20-MCRQ-S Change Notification

20-MCRQ-S pneumatic rotary cylinders will have following changes.

20-MCRQ-S-Ø16/Ø20/Ø25

3. Changed contents

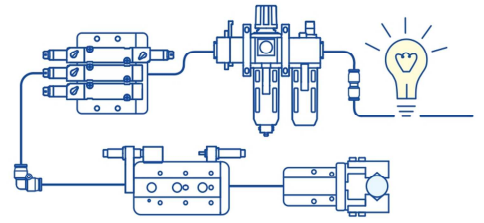
A. Improve the stability of shock absorbers.

B. Revise profile dimensions value in the catalog.

Contents	Size	Before	After
Shock Absorber Order Number	Ø16	20-MAC-1008-3N	20-MDSC-0806-3N
	Ø20	20-MAC-1008-3N	20-MDSC-1008-3N
	Ø25	20-MAC-1412-3N	20-MDSC-1412-3N
Profile Dimension (Code I)	Ø16	99.8	92.8
Profile Dimension (Code M)	Ø16	55.5	48.5
